**Additions and Renovations
Platt Technical High School
Milford, CT**

ADDENDUM NO. 5

August 15, 2019

RA5-03

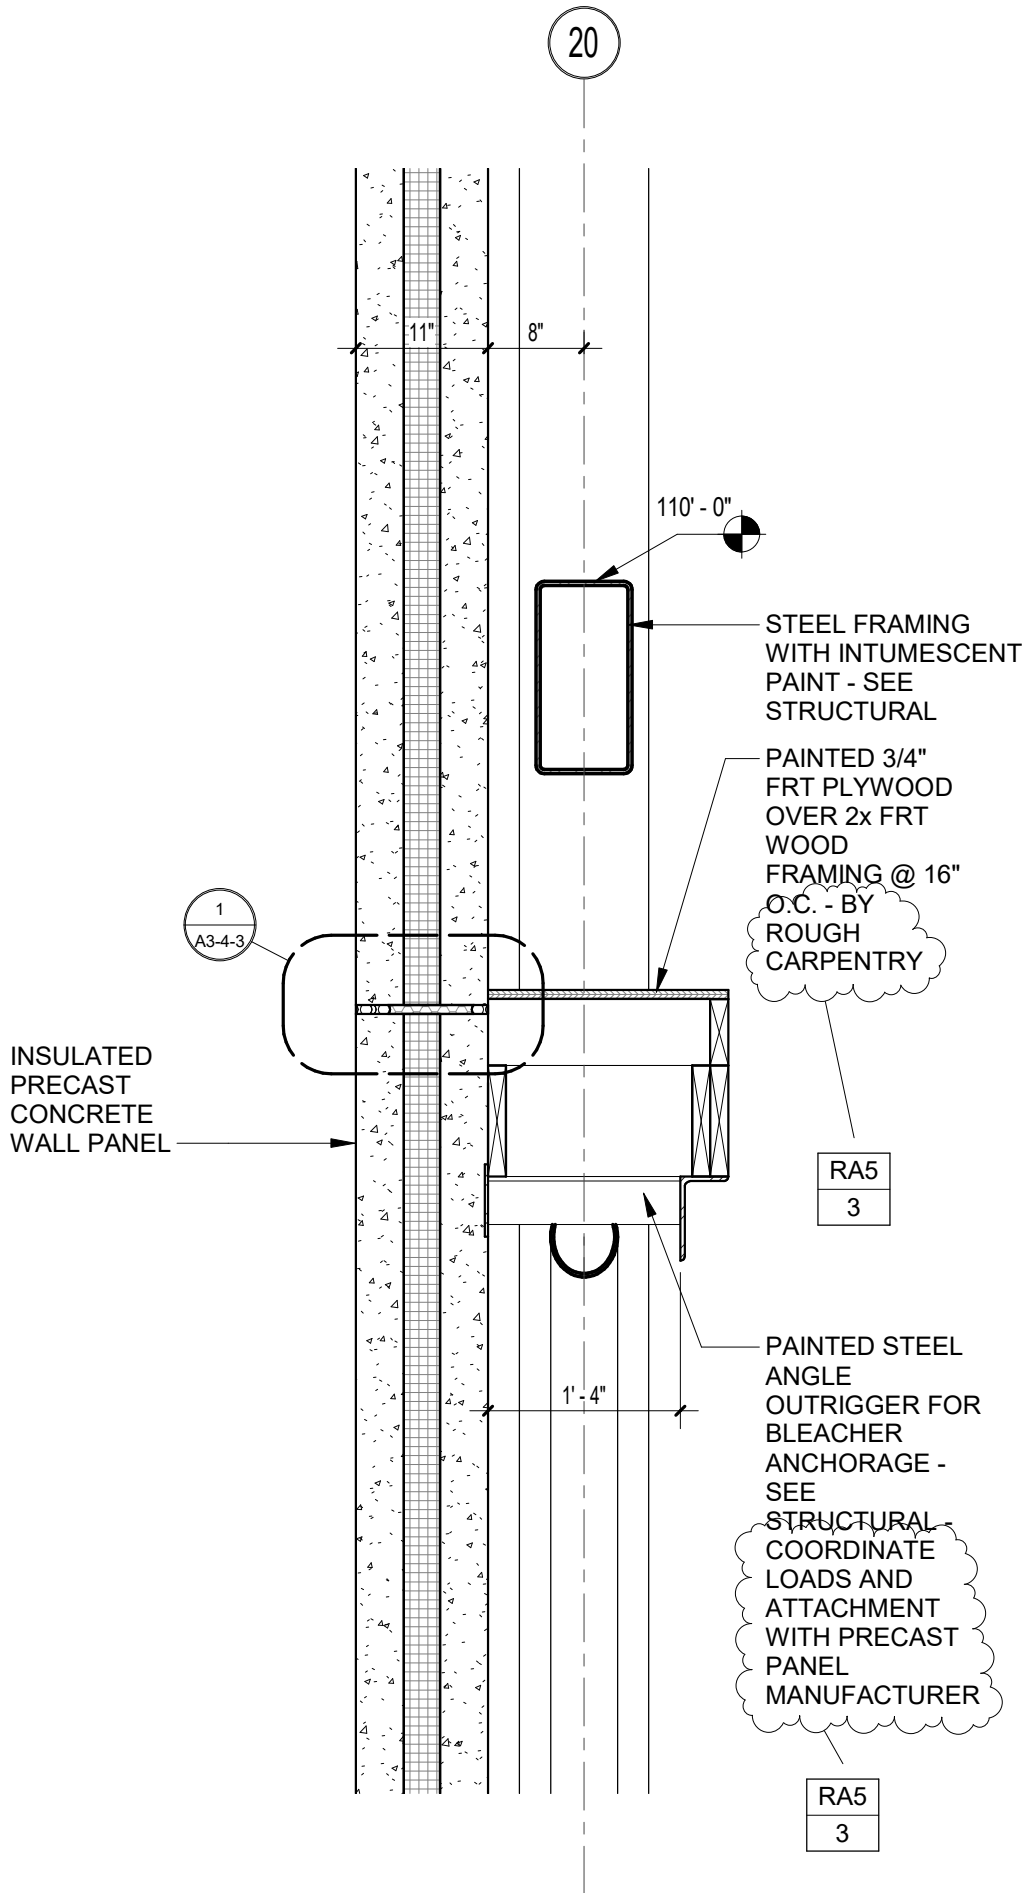
- ADD 5-034 A3-2-4 – WALL SECTIONS**
Section 1: ADD clarification notes on Outrigger Detail for Gymnasium Bleacher per revision Sketch RA5-03.
- ADD 5-035 A3-2-5 – WALL SECTIONS**
Section 4: ADDED Outrigger Detail for Gymnasium Bleacher per revision Sketch RA5-04.

drawing title TRANSLUCENT WALL PANEL/WINDOW AND LOUVER TYPES		date 05/24/2019
drawing no. A6-3-10		scale As Indicated
author		drawn by
approved by		approved by
drawing no.		drawing no.

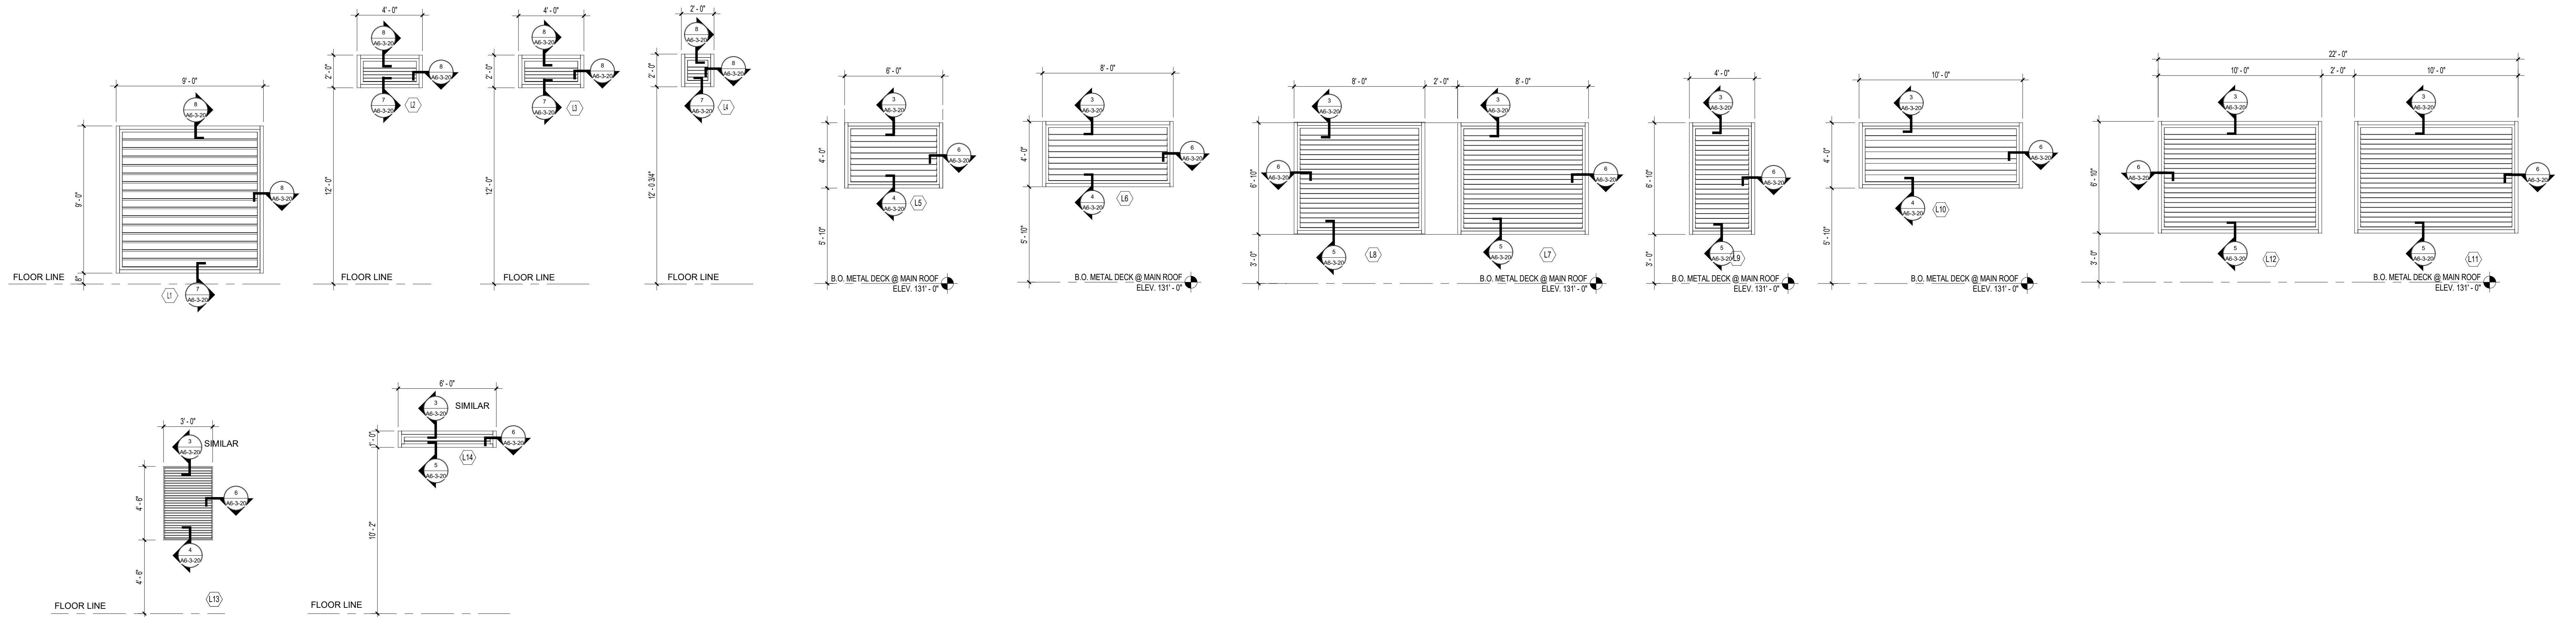
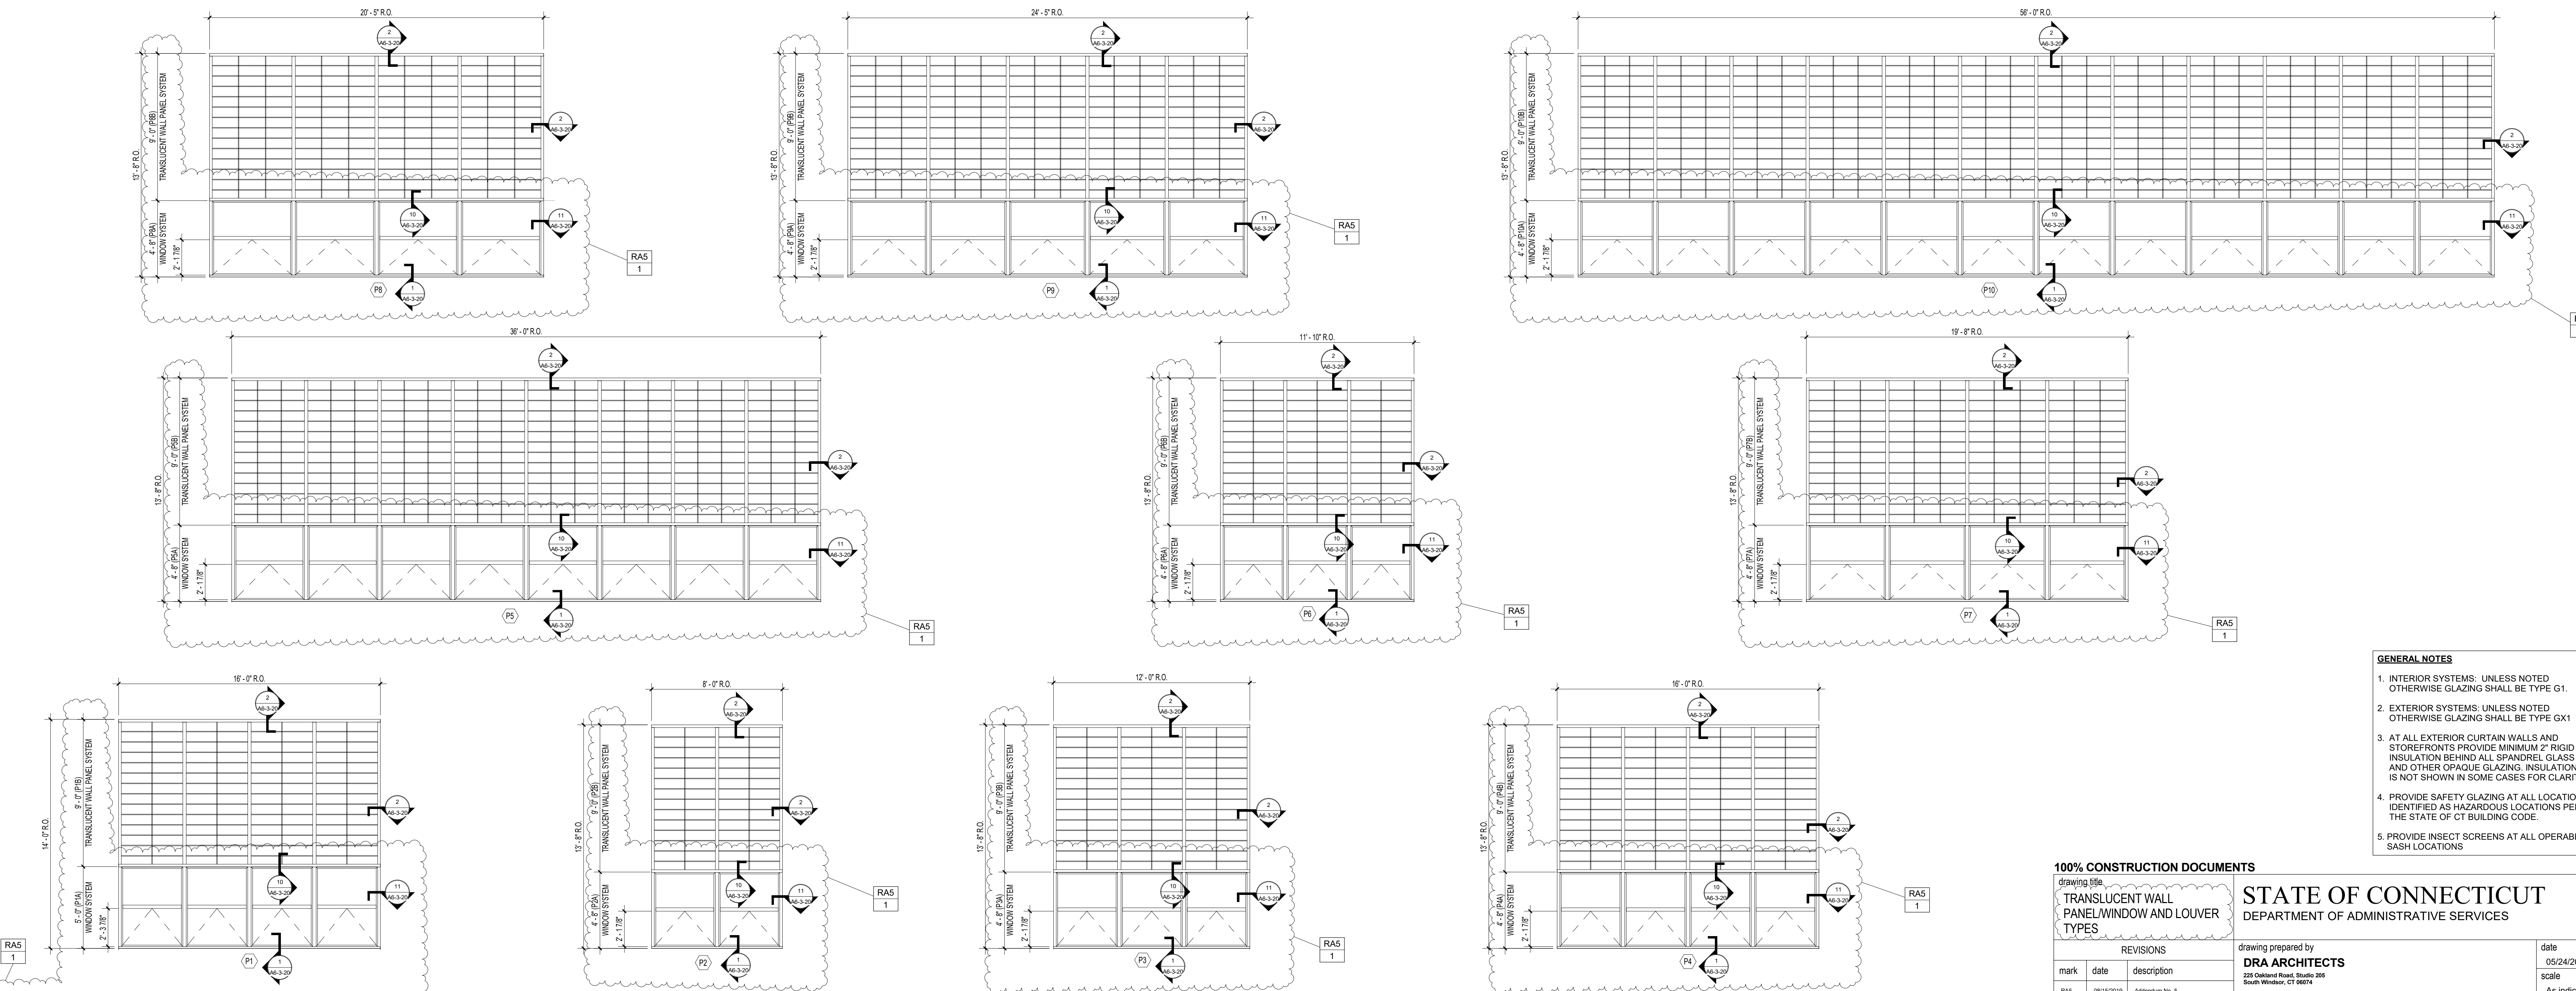
- ADD 5-036 A6-3-10 – TRANSLUCENT WALL PANEL / WINDOW AND LOUVER TYPES**
(previously titled Translucent Wall Panel and Louver Types)
Separated the operable window portion of the Translucent Wall Panels and assigned it to the Aluminum Window System per revision tag RA5-1. Refer to Specification Section 08 51 13, Projected - Fixed Aluminum Windows, included within this Addendum. This occurs at Translucent Wall Panel/Window Types P1 through Type P10.

1 WINDOW SILL DETAIL
3" = 1'-0"

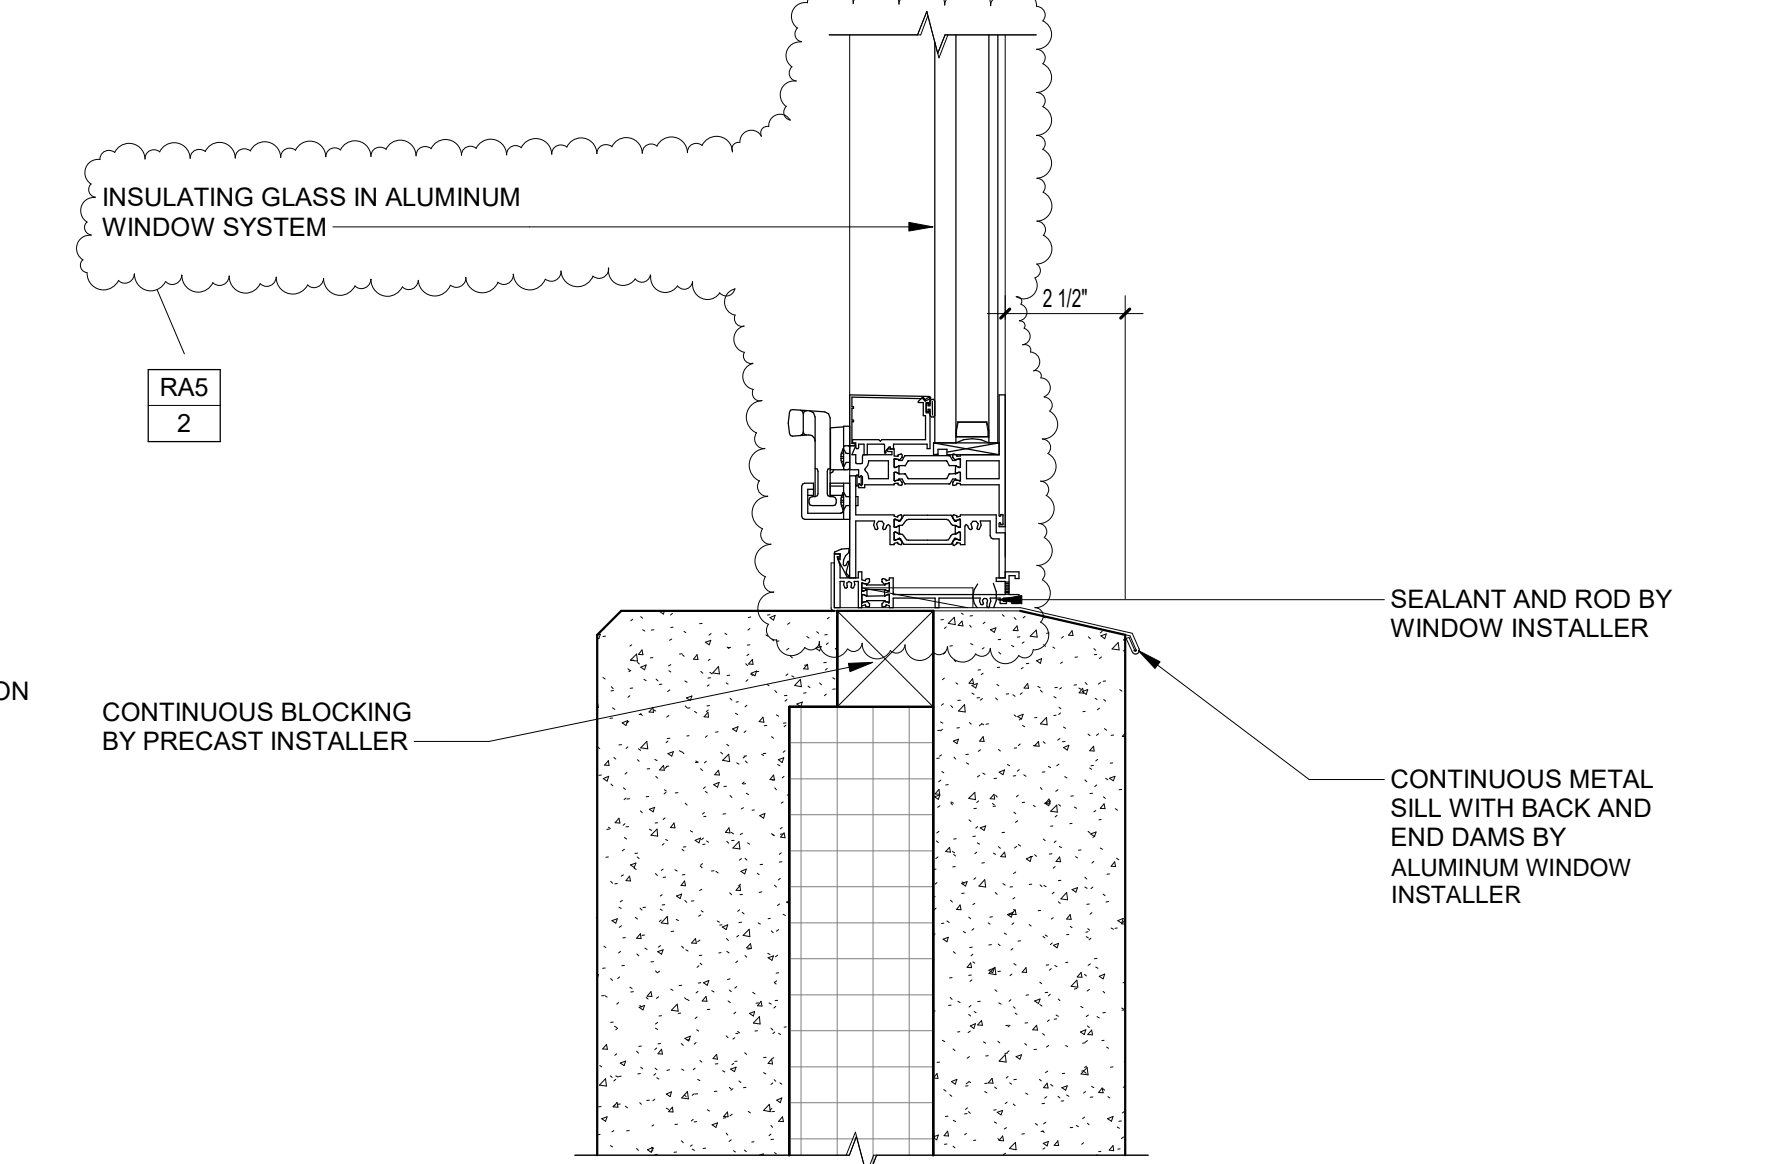
- ADD 5-037 A6-3-20 – TRANSLUCENT WALL PANEL AND LOUVER DETAILS**
Detail 1: Revised sill detail from Translucent Wall Panel to Window System per revision tag RA5-2.
Detail 10: ADD Detail 10, Translucent Wall Panel Sill / Window Head Detail, per revision tag RA5-2.
Detail 11: ADD Detail 11, Window Jamb Detail, per revision tag RA5-2.
